**PPPL ENGINEERING CHANGE NOTICE (ECN) ECN # 5140R2**

<b>COGNIZANT INDIVIDUAL: Dave Williamson</b>	
<b>ECN TITLE: Changes to Modular Coil Lead Area Design</b>	
<b>ASSOCIATED ECP: None</b>	
<b>CC/WP/Job: 9450-1***-1451</b>	<b>AREA OR PROJECT: NCSX</b>

The purpose of these lead area design changes is to mitigate technical risks that have come to light in the course of testing the C1 Modular Coil. **Revision 2 changes highlighted in yellow and test removed has strikethroughs.** The following changes are proposed:

Figure 1

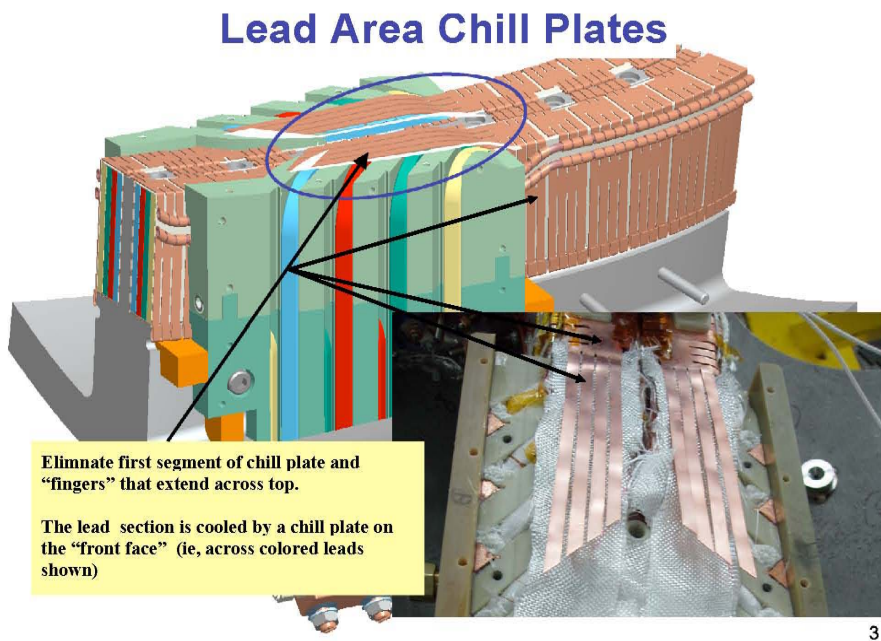
- On the top chill plate (the one with the long fingers that extend parallel to the coil) – cut off the fingers and eliminate the chill plate. **(See Figure 1)**. *This change will be implemented for the C3 and follow-on coils.*

**Figure 2**  
**Lead Area Cladding- Lower**

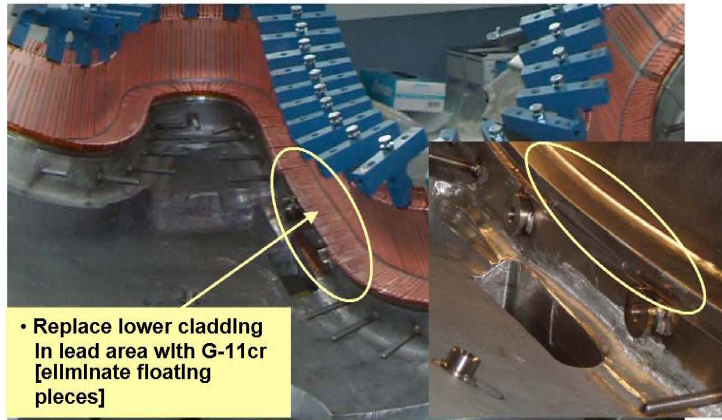
- Isolated copper cladding pieces (located on the base of the tee underneath the winding pack in the lead area, the vertical cladding pieces in the same area, and the cladding in the poloidal break area) – change the material to G-11cr. **(See Figure 2)**. *This change will be implemented starting with the C5 and follow-on coils. Note: The G-11 pieces should be made to look like the cladding (with slots) so that forming to the shape and wicking of epoxy will be that same as for other areas.*

**Figure 3**  
**Power Bus Tie-in Area**

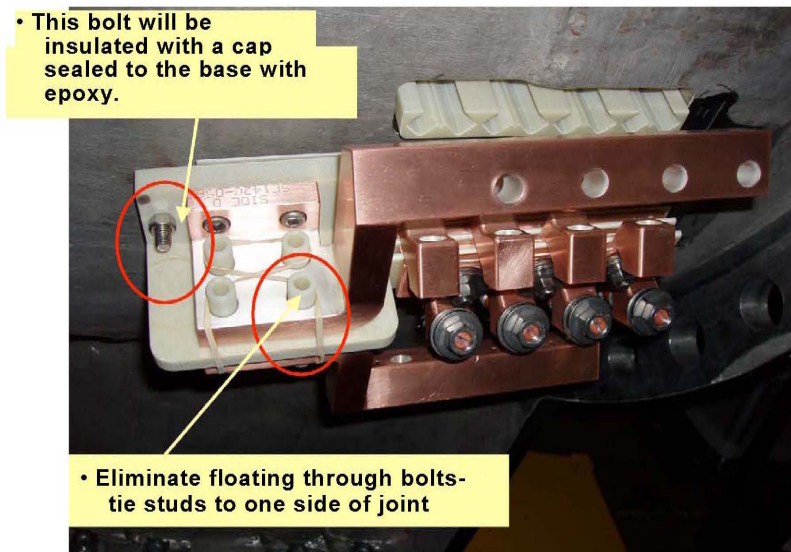
- For the power bus tie-in area, **install Kapton sheet over attachment bolt** ~~cap the attachment bolt with an epoxy seal~~ to mitigate a potentially short tracking path. **(See Figure 3L)**. *This will be implemented on all coils.*

- Presently the four bolts that connect the power bus are floating which is an undesirable condition **(See Figure 3R)** - connect them to one side by eliminating the insulating washers on the other side. *This will be implemented on all coils.*

**Figure 4**  
**Improve Tracking Distance**

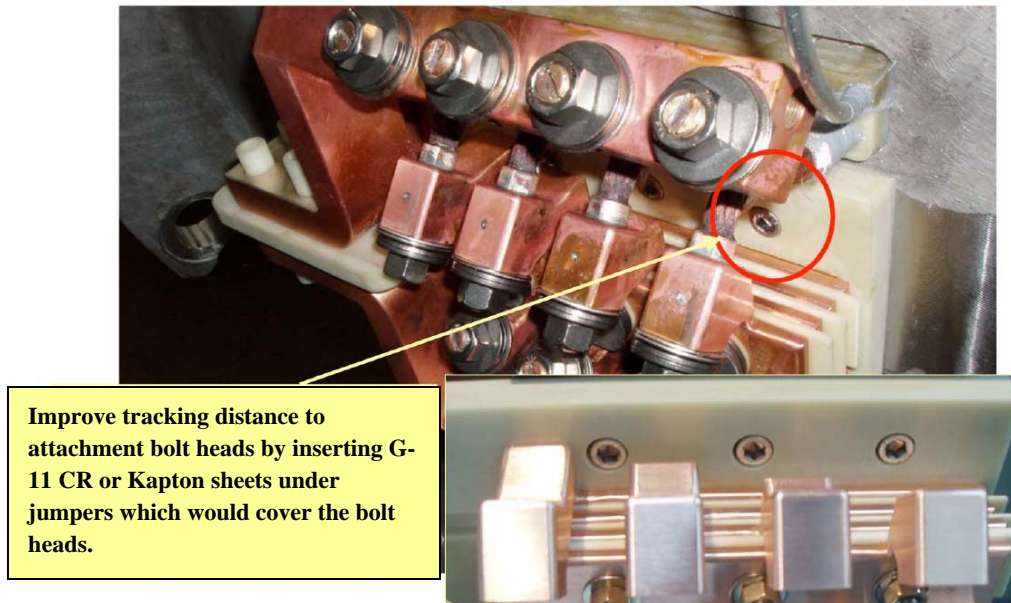
- The bolts that attach the G-11 base plate underneath the jumper stack – put a cover (Kapton or thin G-11 sheet) to increase the tracking distance. **(See Figure 4)**. *This will be implemented on all coils.*
